ADDENDUM NO. 3
10/21/2019

NEW PORTABLE CLASSROOM BUILDING
Camarillo Academy of Progressive Education

PBK Project No.: 191726

ADDENDUM NO.3 - AD-3.0

REVISIONS: DATE:

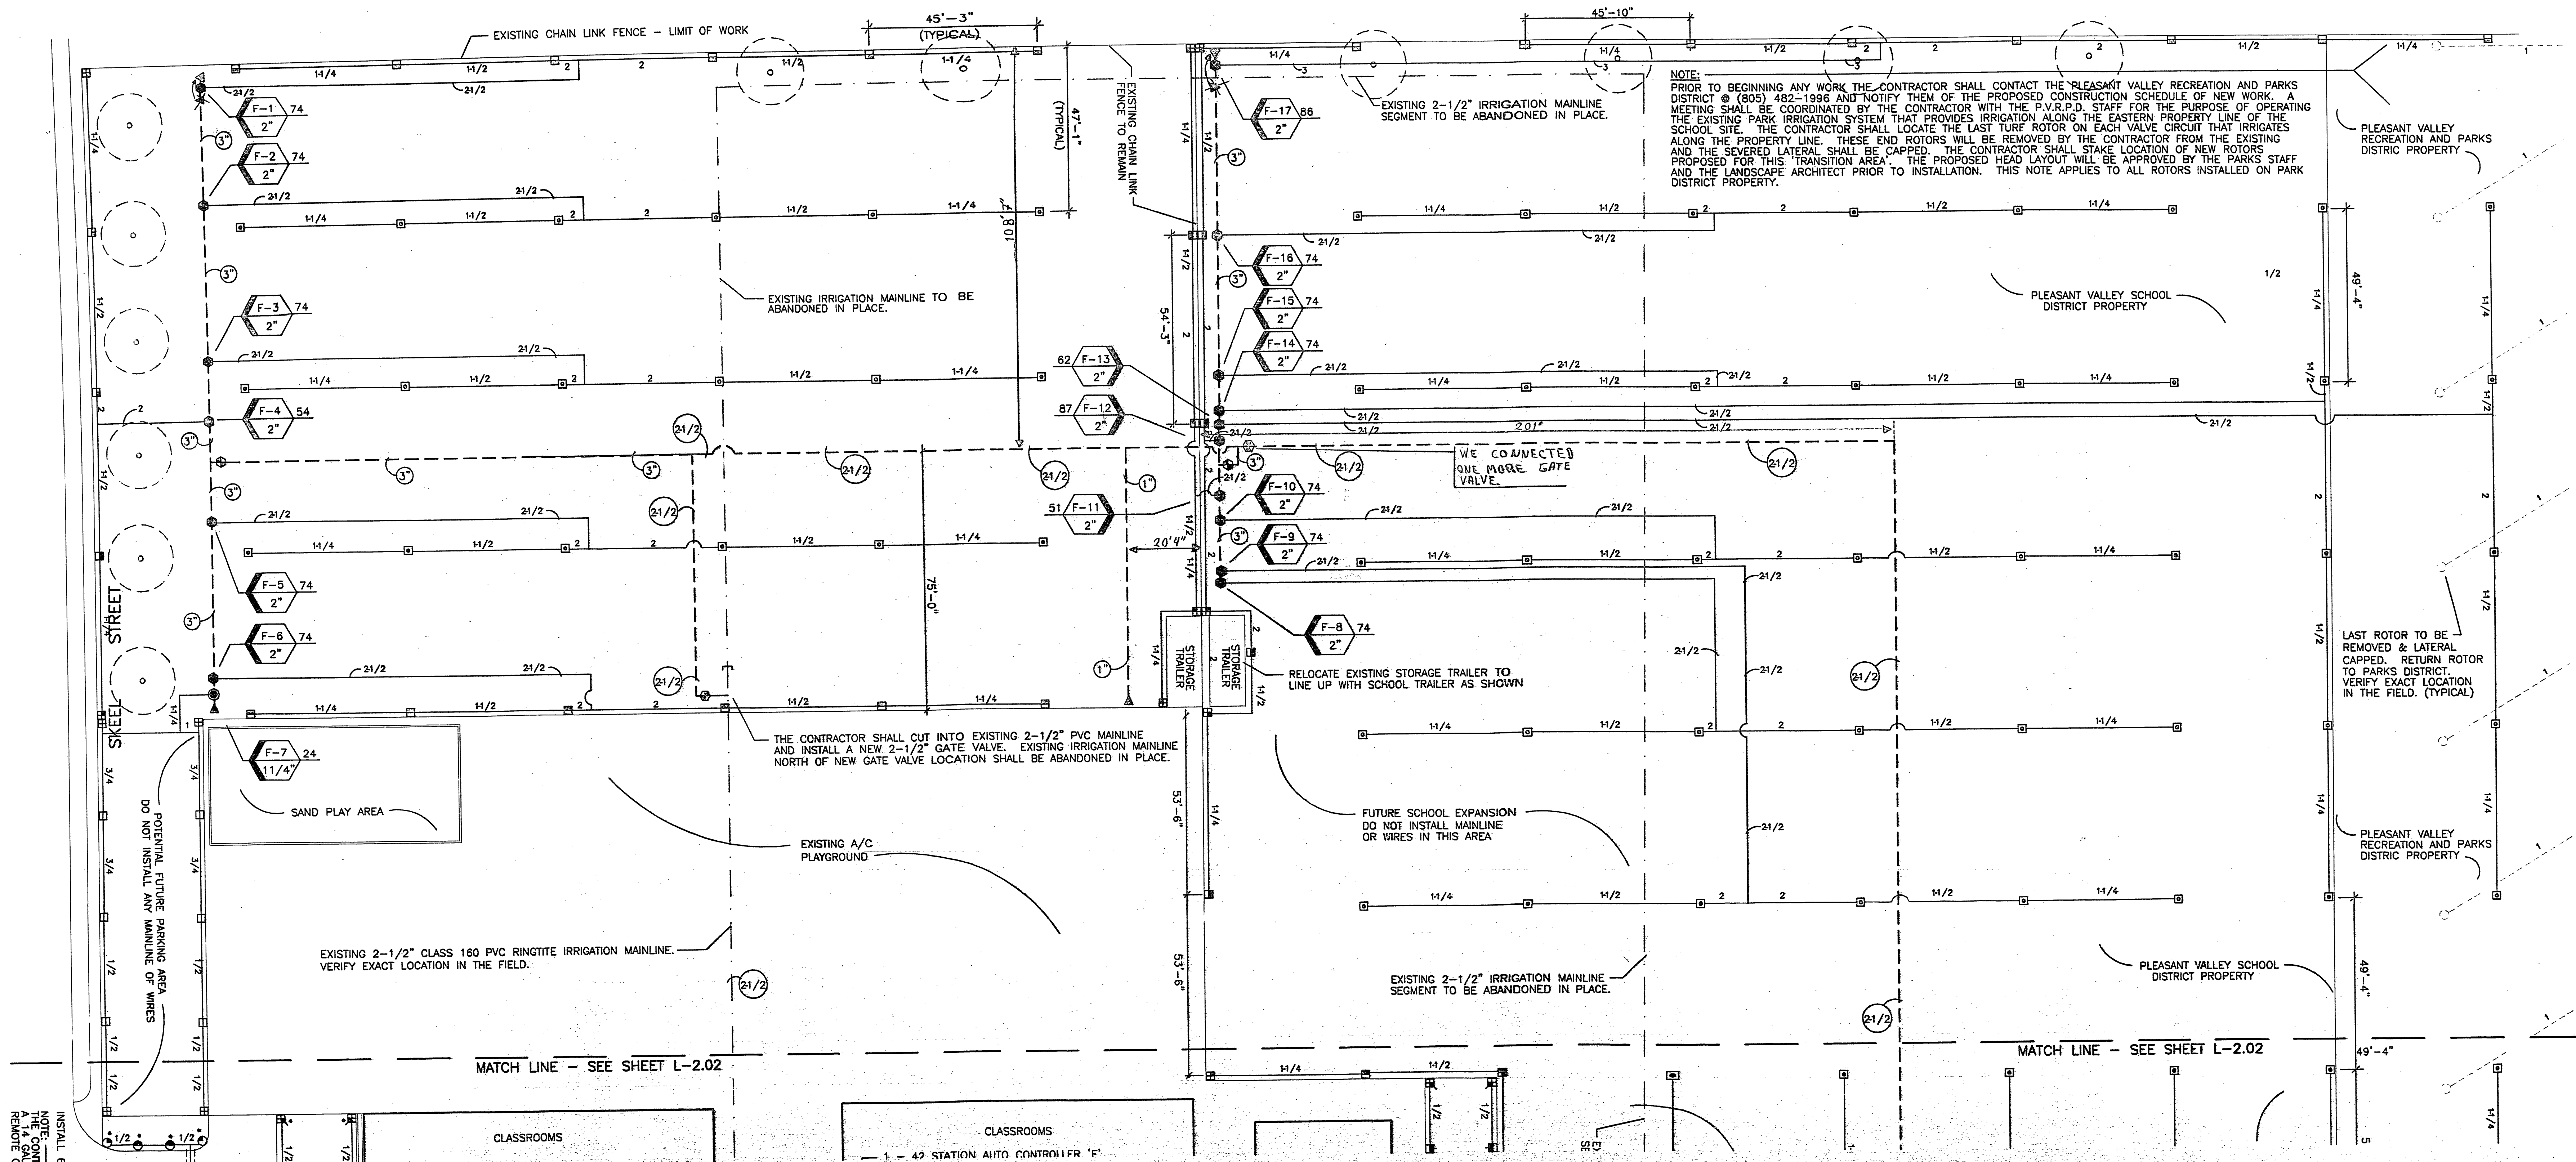
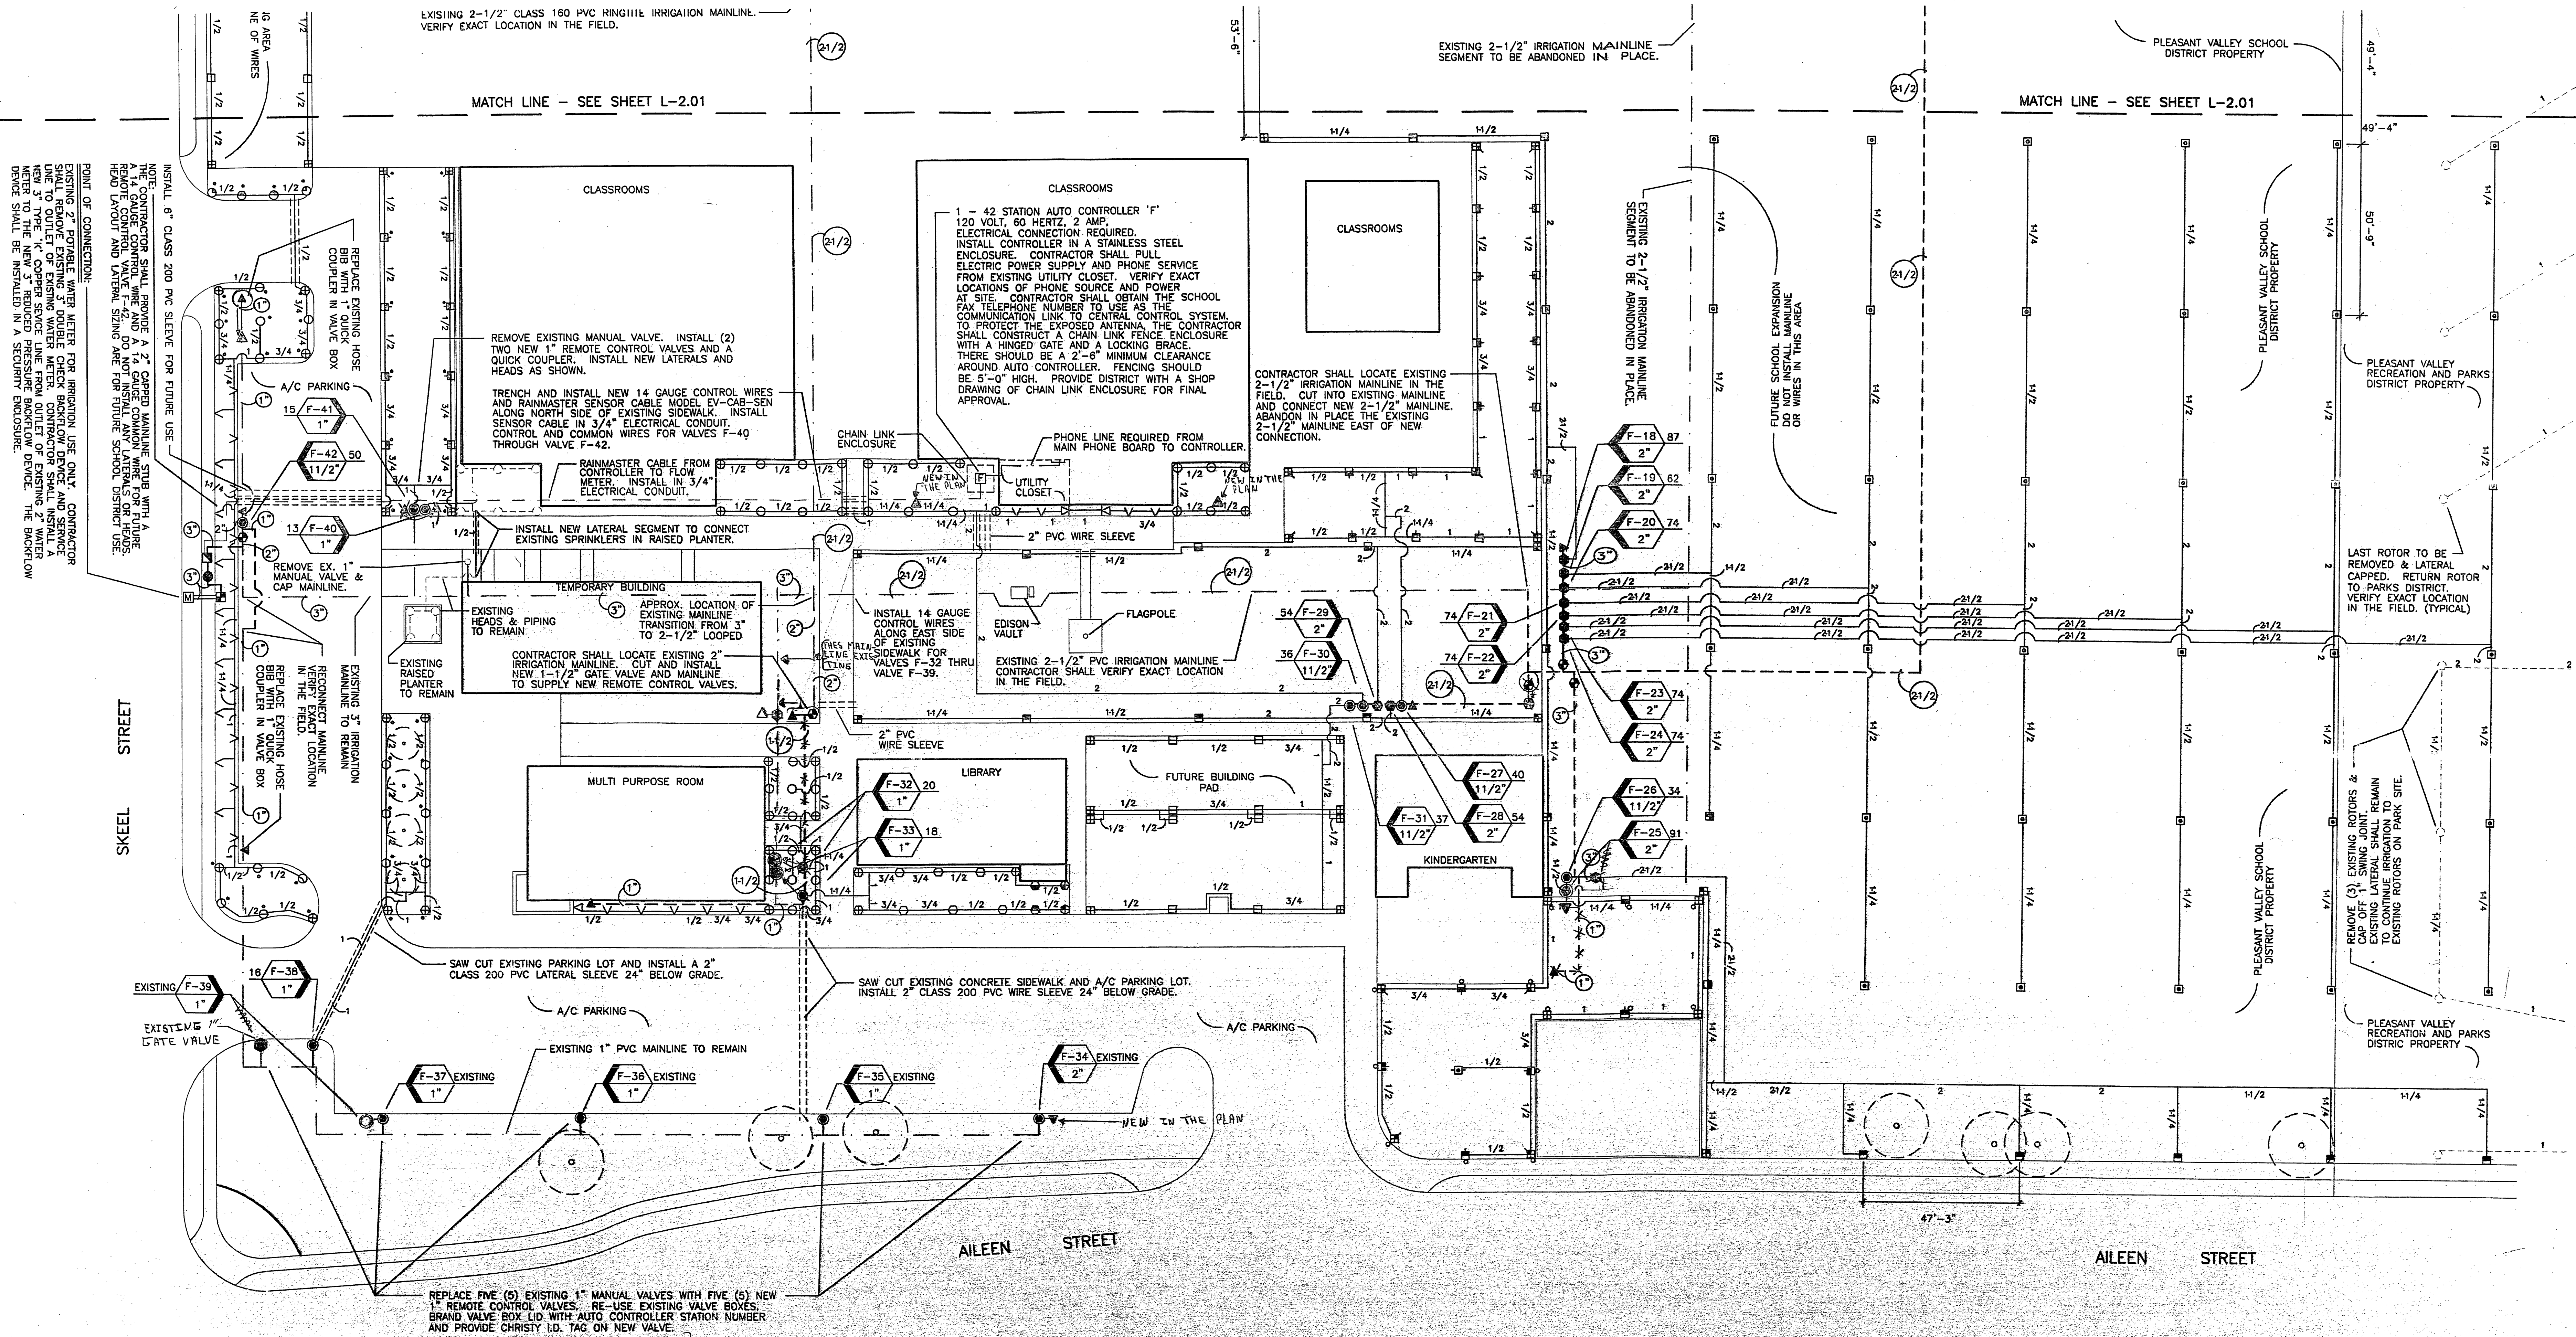
4. AD-3.4 Landscape and Irrigation Record Drawings
A) See attached for landscape and irrigation record drawings.

5. During the site walk it was noticed allot of irrigation valves that will impact the project. Does the District know the lines location? Will the District cap off the lines under the new project?

RESPONSE: Contractor is responsible to cut and cap existing sprinkler lines that are affected by new construction. See attached drawings for approximate irrigation system layout and coordinate with Owner prior to irrigation system modification.
